Re: Mixed Use Development at Burroway Road, Wentworth Point (SSD 6387)

Response to Relevant 'Water Management and Flooding' Matters in Auburn City Council Comments (c/- NSW Planning & Environment, 31 July 2014)

RE: SOPA Wentworth Point- Mixed Use Development

Advice on Stormwater Management at Burroway Road / Hill Road Intersection

ATTACHMENT A - 'BROWN CONSULTING' CATCHMENT PLAN / CALCULATIONS

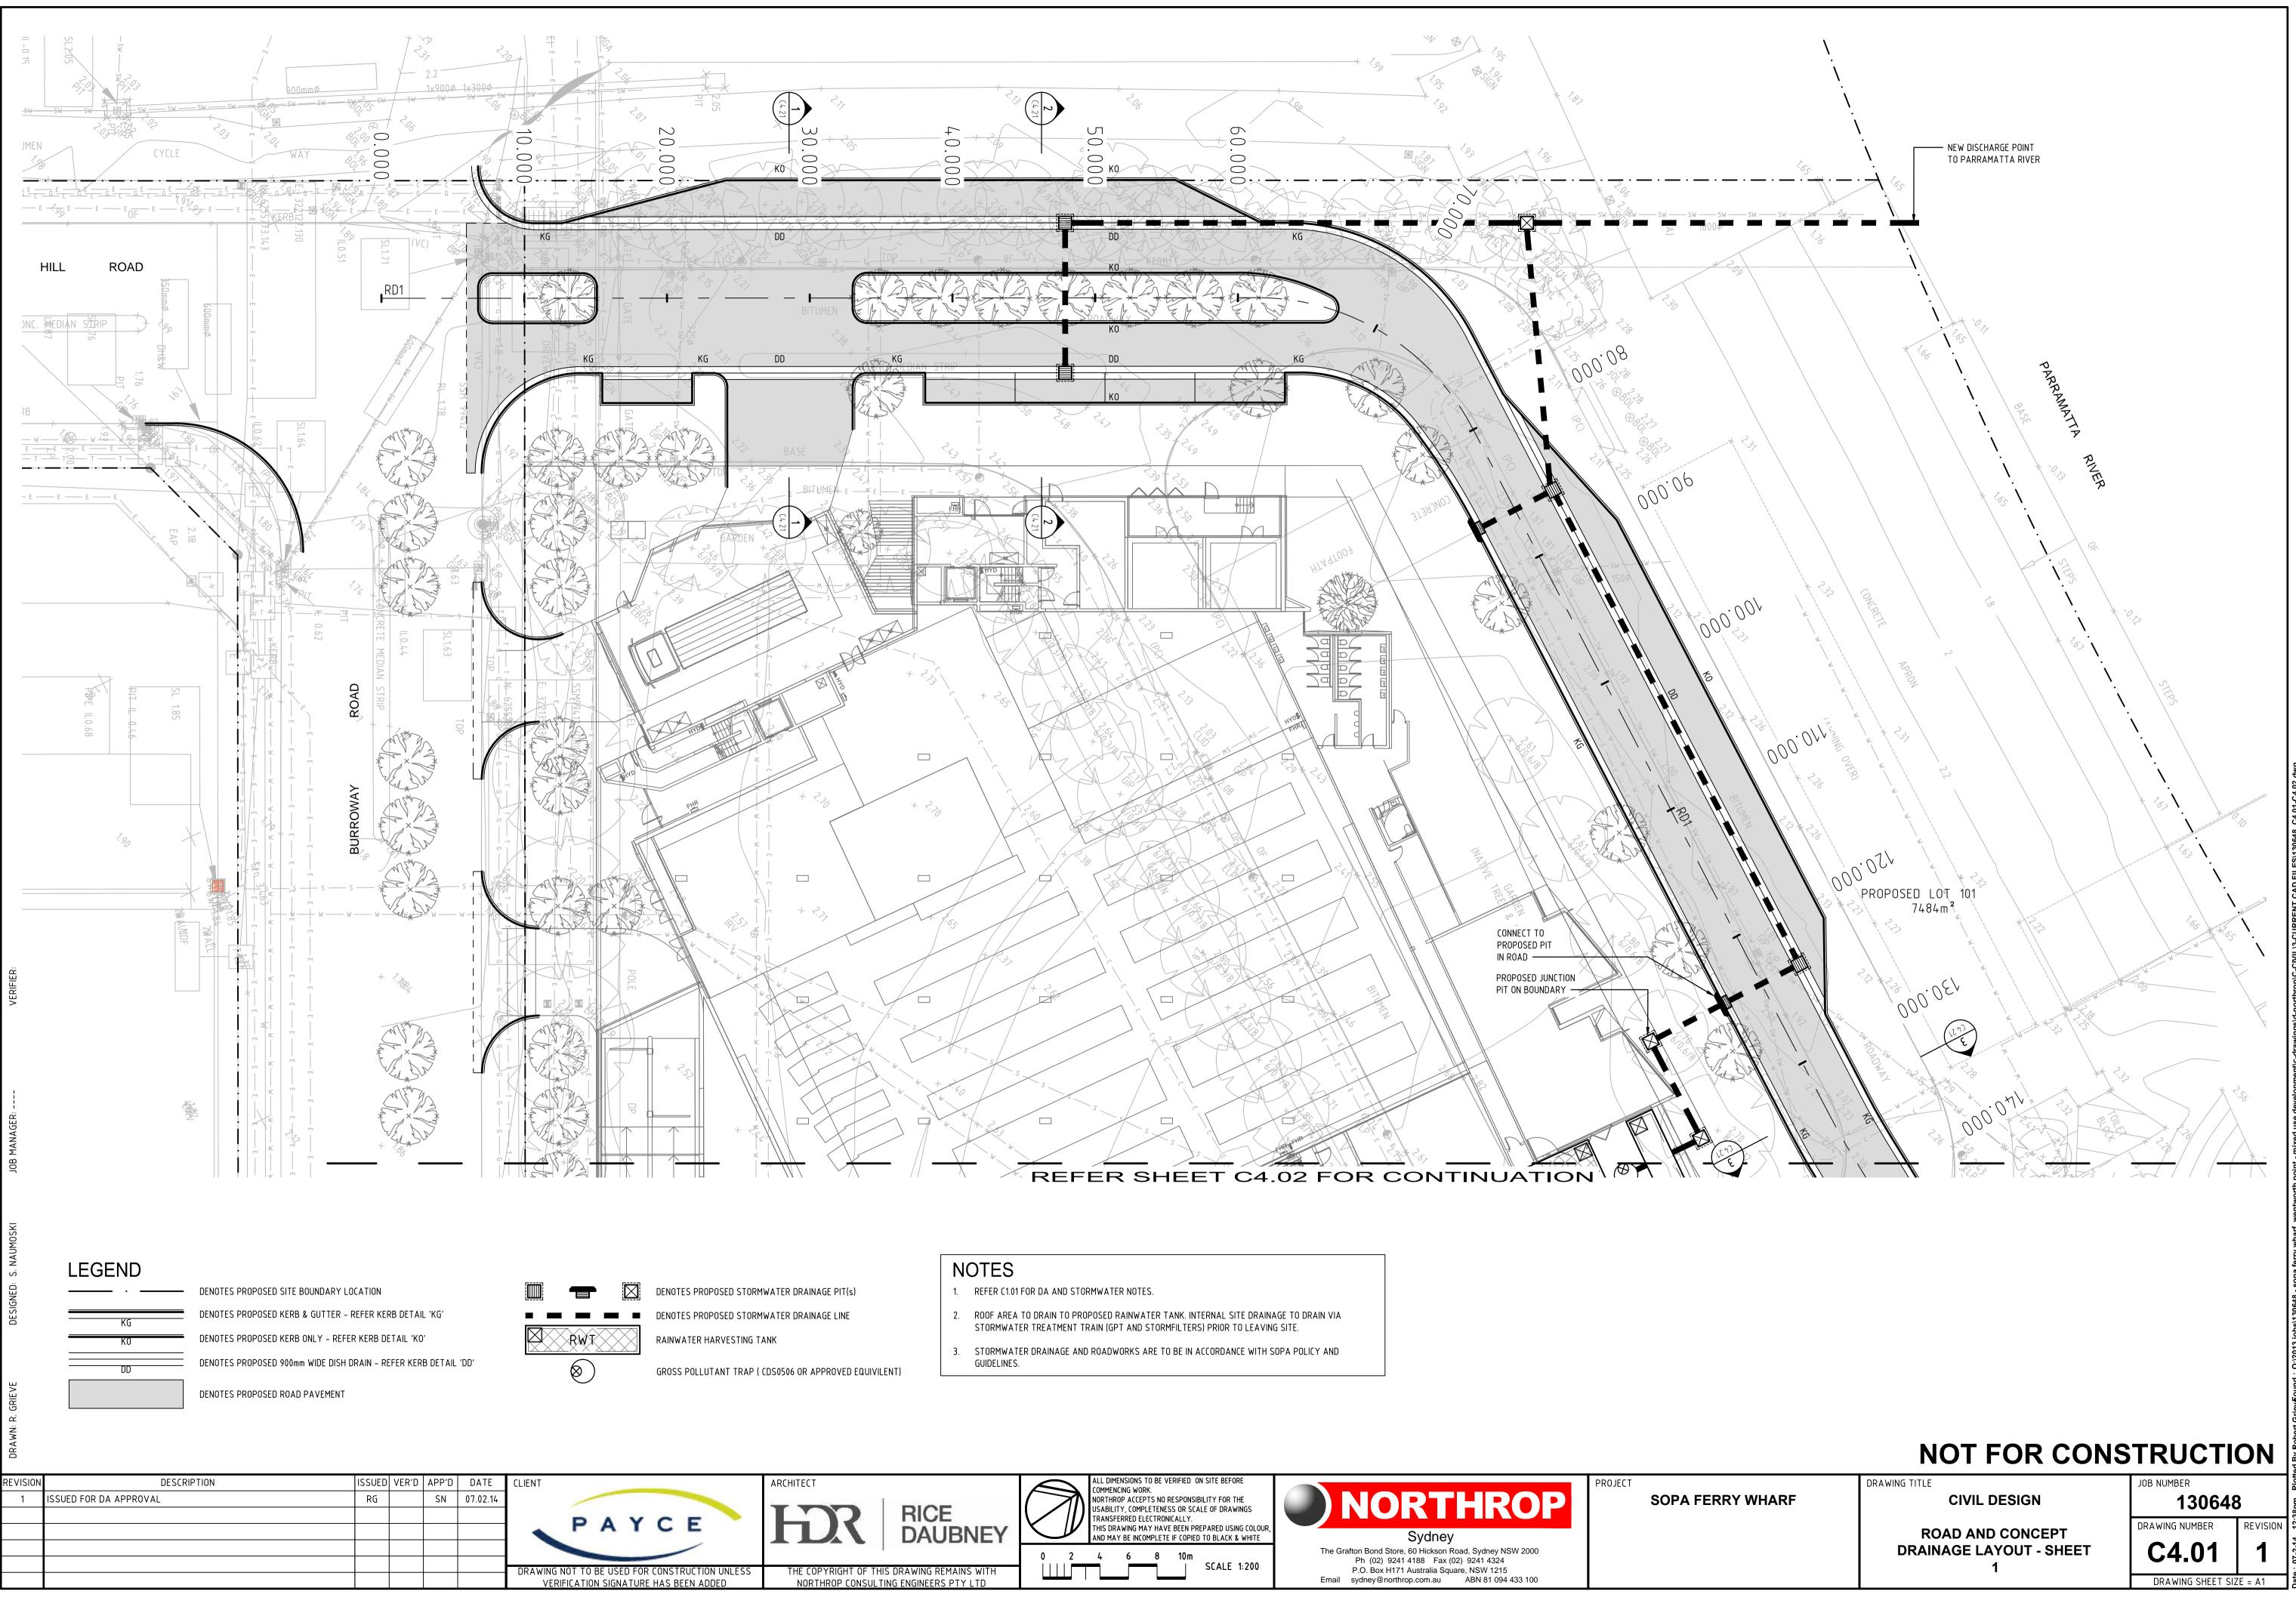
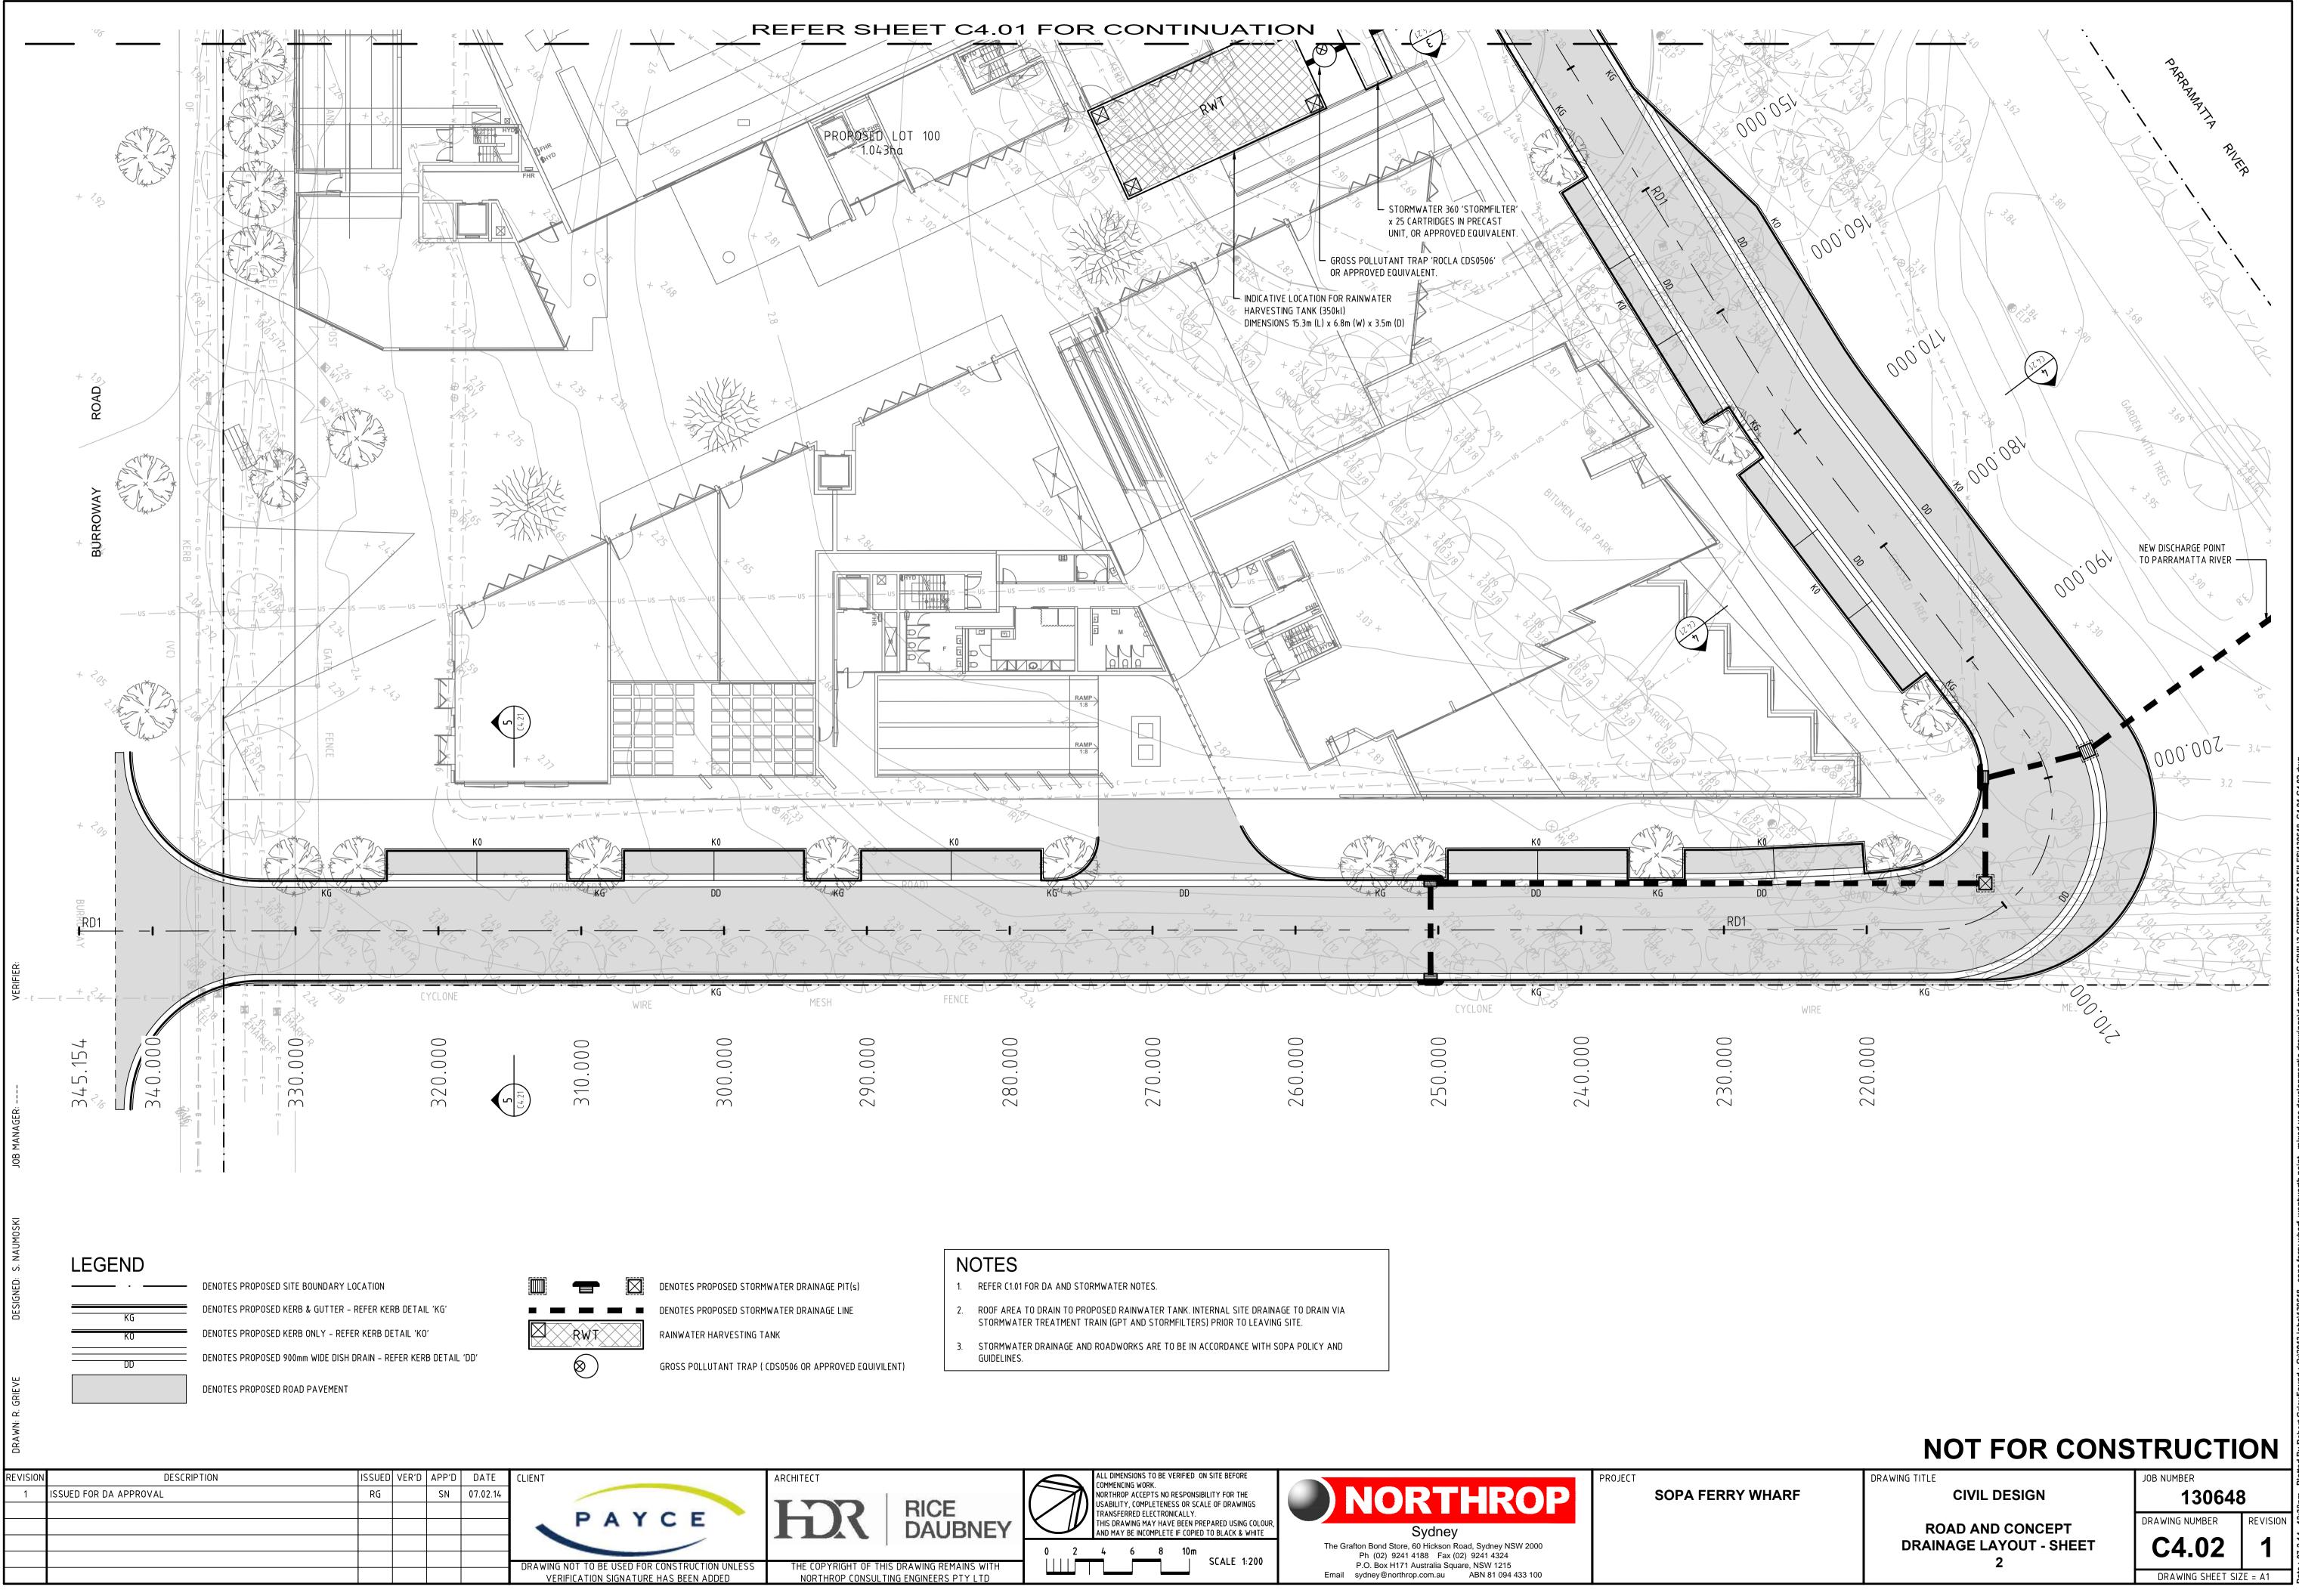
- 3. The calculations by Brown Consulting indicate the total flow from the existing catchment to the intersection of Burroway and Hill Road. Northrop estimates approximately 50% of this flow will affect the north-eastern corner of the subject intersection. The remaining 50% has been deemed to remain west (or on the western side) of Hill Road and therefore not affect the eastern side of the intersection.

- 5. The proposed road cross-section has capacity to convey approximately 2.8m³/s of overland flow. This equates to the gap flow Brown Consulting has calculated for the 100-year ARI event

– allowing for a 1-year ARI capacity (only) for the existing pit / pipe system. Again, we note this is based on 50% of the total flows calculated by Brown Consulting affecting the (subject) eastern side of the intersection.

ATTACHMENT C - 'NORTHROP' MARKED-UP STORMWATER MANAGEMENT SKETCH

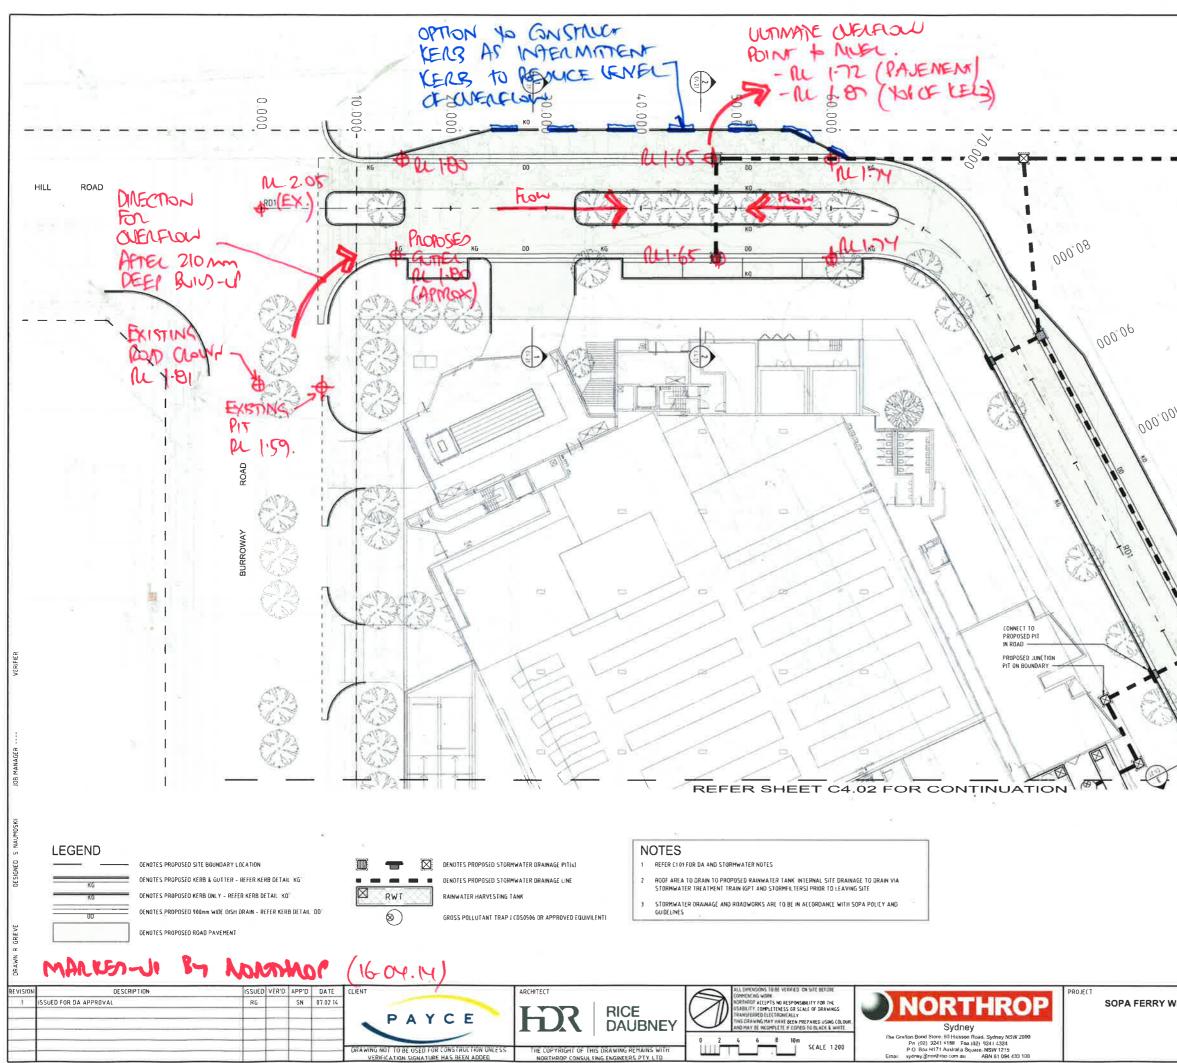
Northrop has reviewed background information (including the calculations for the existing contributing catchments, prepared by Brown Consulting – copy attached). The following comments are provided to confirm design measures to convey runoff from the north-eastern corner of the subject intersection to the Parramatta River. We refer also to the attached marked-up sketch diagram, prepared by Northrop.

6. The relief point for overflow from the proposed Hill Road extension to the River is at proposed Road Chainage 50 (approx.). Intermittent kerbs along the western edge of the parking / setdown area (in lieu of continuous, full-height kerb) present an opportunity to enable overflow at pavement level (rather than top of kerb, i.e. 150mm higher). This would be subject to SOPA accepting intermittent kerbs (in lieu of barrier kerb), adjacent the set-down area.

- The current design incorporates measures to manage overflow away from the north-eastern corner of the Burroway / Hill Road intersection.
- The incorporation of intermittent kerbs along the western side of the parking / set-down area to the proposed Hill Road extension will lower the level before overflow will continue to the Parramatta River.
- These principles will need to be considered in the stormwater management strategy for the overall Wentworth Point UAP – being developed by Brown Consulting (on behalf of UrbanGrowth NSW). In this regard we note the current design information indicates Burroway Road will continue to drain further west to the proposed overland flow path (west of Hill Road) – thereby further relieving stormwater runoff from the subject intersection.
